TO: PLANNING COMMISSION

SUBJECT: SUPPLEMENTAL STAFF REPORT FOR COMPREHENSIVE PLAN CHANGE / ZONE CHANGE NO. 21-04; 2900 BLOCK OF KUEBLER BLVD SE (AMANDA APPLICATION NO. 21-115803-ZO; 21-115805-ZO)

SUBJECT: RESPONSE TO CITY OF SALEM COMMENTS: BOONE ROAD COMMERCIAL TPR ANALYSIS (ROUND 2)

- A. Concept Design Layout & Cost Estimate for 27th Avenue between Kuebler Blvd and Site Access
- B. Revised Figure 3 (Trip Generation & Distribution)

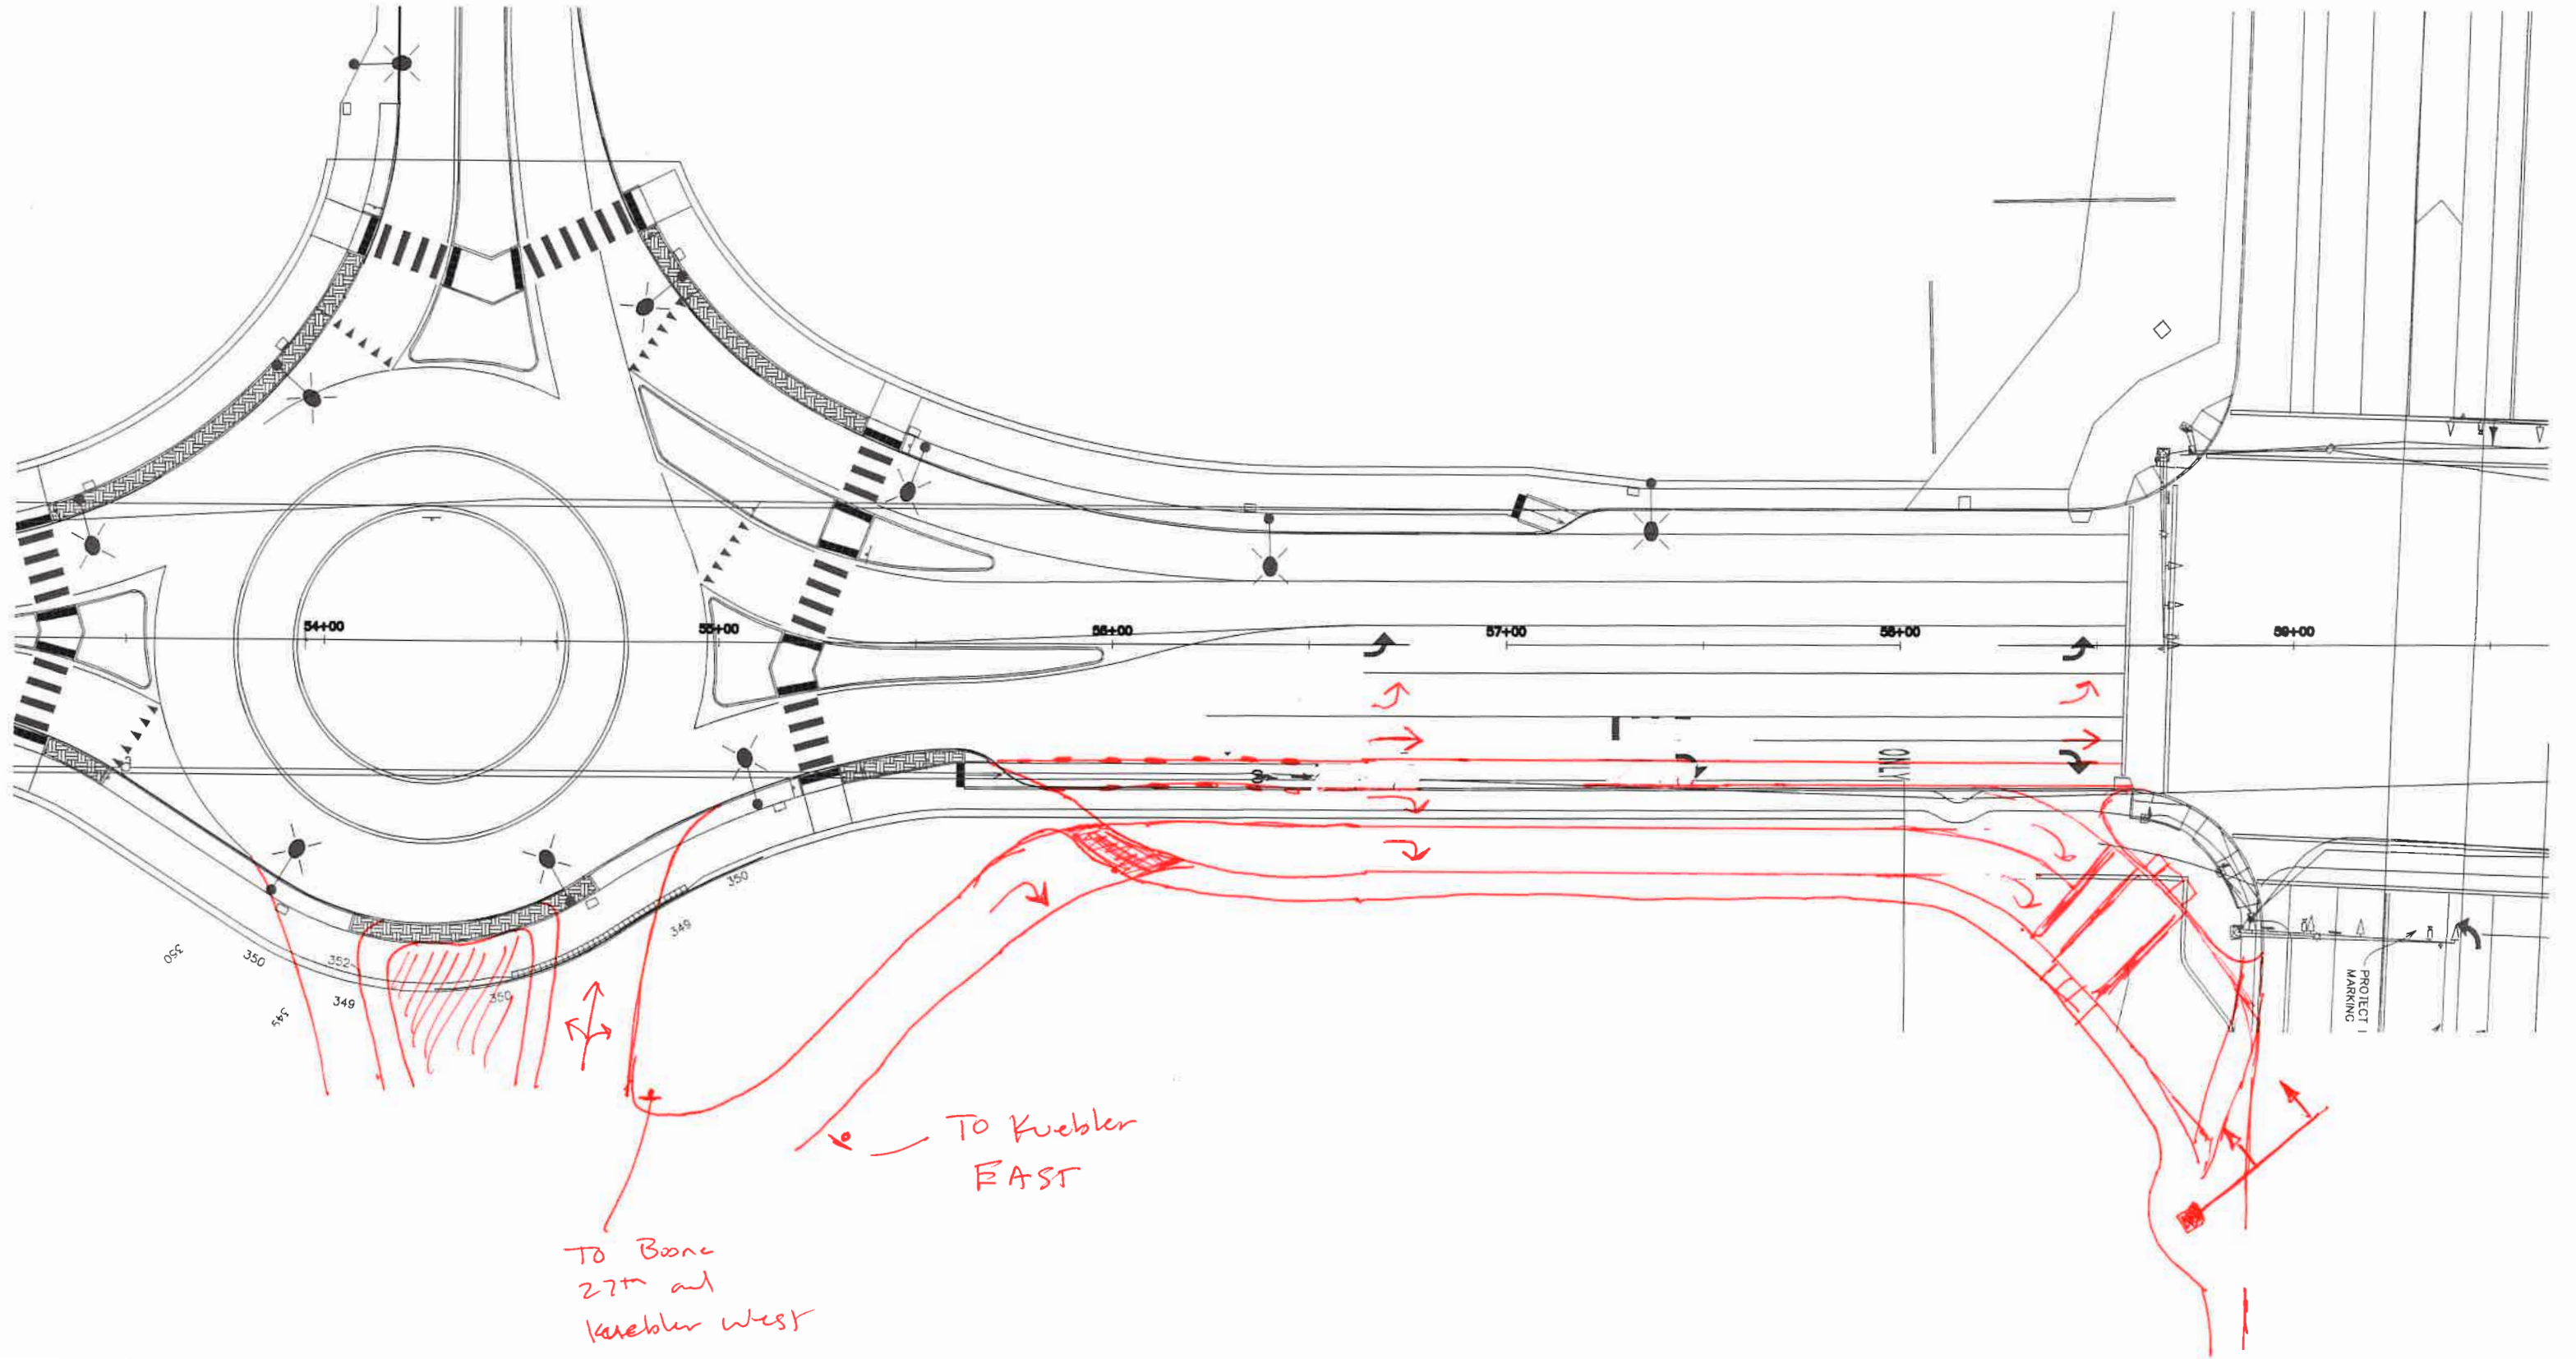
2. Proposed mitigation is for double left turn lanes and double right turn lanes for NB 27th at Kuebler. Need to show how that would be designed. It is unclear how the lanes would function coming off round-about and the site driveway.

7. Proposal to add a second lane to the round-about. There is not enough weaving distance for the various movements, especially since the queues extend beyond the available lane lengths.

DKS: Refer to Attachment A for a conceptual design layout showing the segment of 27th Street between Kuebler Blvd and the site access roundabout for the proposed mitigation. An updated cost estimate for the project is also provided in the attachment.

DKS: See the concept design in Attachment A. Two northbound lanes are provided as vehicles exit the roundabout. Guide signage on-site directing vehicles to select the desired lane prior to entering the roundabout will limit weaving within this segment.

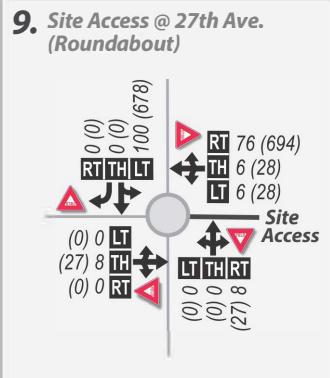
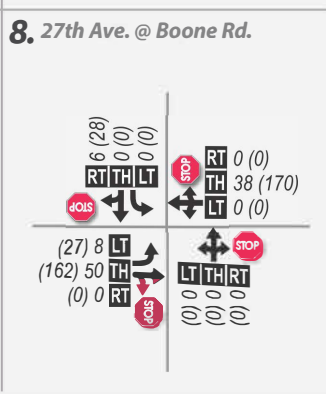
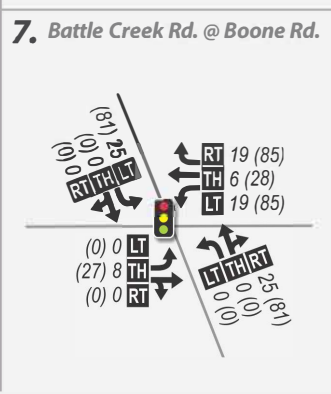
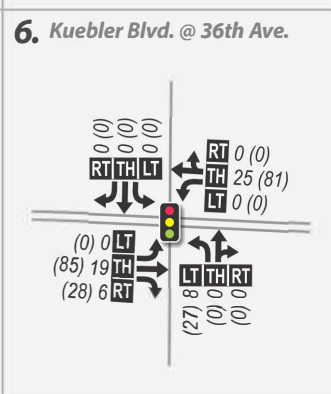
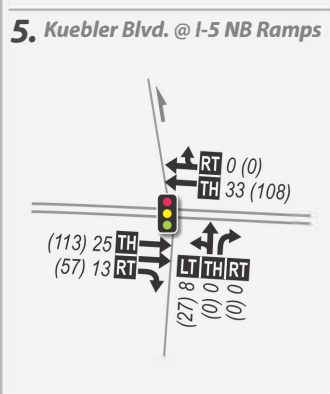
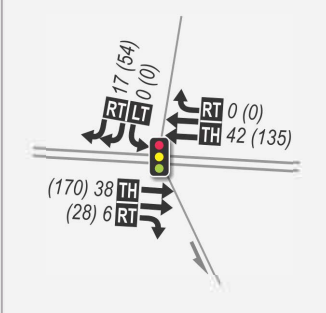
15. Traffic volumes on Figure 3 don't match with Table 8.

DKS: This has been discussed with City Staff. The turning volumes in Figure 3 match the total trip generation in Table 8; the summary of Primary and Pass-by trips shown in the table near the bottom of Figure 3 is incorrect. A revised version of Figure 3 is in Attachment B.
